## **Nevada Division of Environmental Protection BART Determination Review of NVEnergy's Fort Churchill Generating Station Units 1 and 2**

A BART analysis was completed by CH2M HILL at the request of NVEnergy (NVE) for units 1 and 2 at the Fort Churchill Generating Station (Ft. Churchill) dated October 3, 2008. Fort Churchill consists of two BART-eligible units with a generating capacity of 113 megawatts each. The fuel currently used in units 1 and 2 is pipeline quality natural gas (PNG) or blended fuel oil (No. 6 residual oil and No. 2 distillate fuel oil). In completing the BART analysis, technology alternatives were investigated and potential reductions in NO<sub>x</sub>, SO<sub>2</sub> and PM<sub>10</sub> emissions rates were identified by NVE. NVE's BART analysis is summarized below, organized according to the five step analysis contained in Appendix Y of 40 CFR 51, followed by NDEP's review and BART determination.

**FIGURE 1**  
**LEAST COST ENVELOPE**

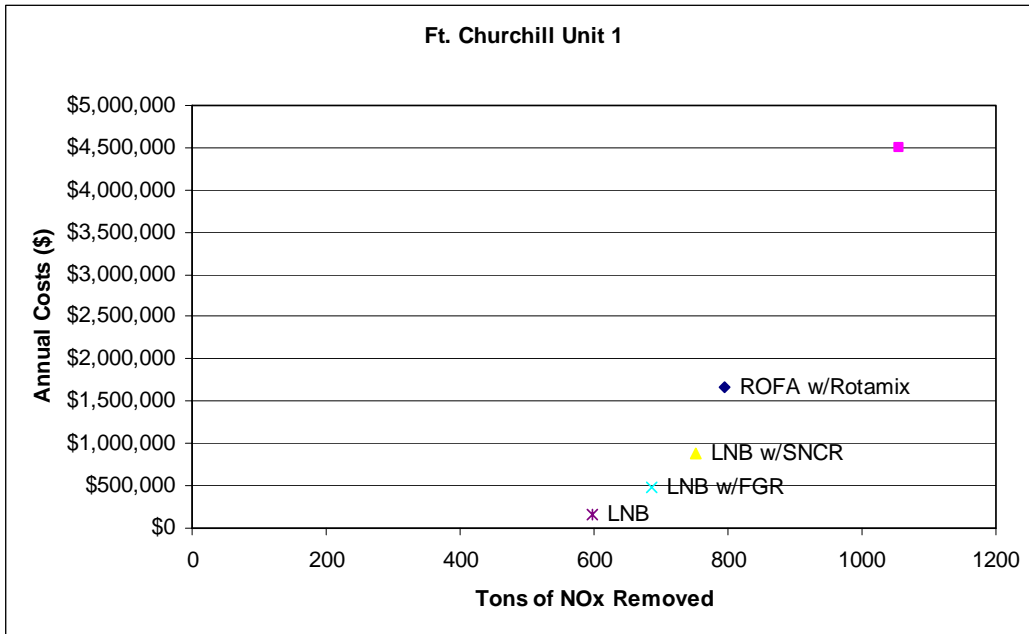
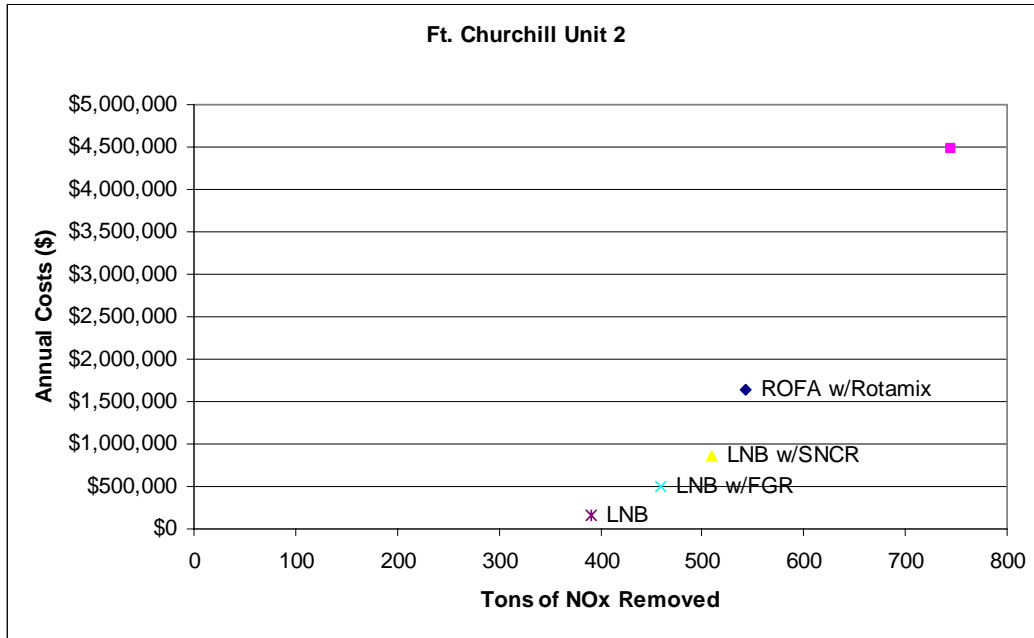
NDEP specifically reviewed the cost per ton of NO<sub>x</sub> removed for each unit at Fort Churchill and determined that installation of LNB with FGR meets the BART criteria, with associated first

year costs of \$716 and \$1,070/ton of NO<sub>x</sub> removed for units 1 and 2, respectively. These values are considered cost effective. The cost data from the tables above are presented graphically in Figure 1. NDEP also concluded based on a review of the economic analysis that the \$/ton of NO<sub>x</sub> removed increased significantly for LNB with SNCR, ROFA and SCR technologies with only slight improvements in visibility.

Based on this review, NDEP concludes that for NO<sub>x</sub> the installation of LNB with FGR with an emission level at 0.20 lb/MMBtu for unit 1 and 0.16 lb/MMBtu for unit 2, on a 12-month rolling average, is BART.
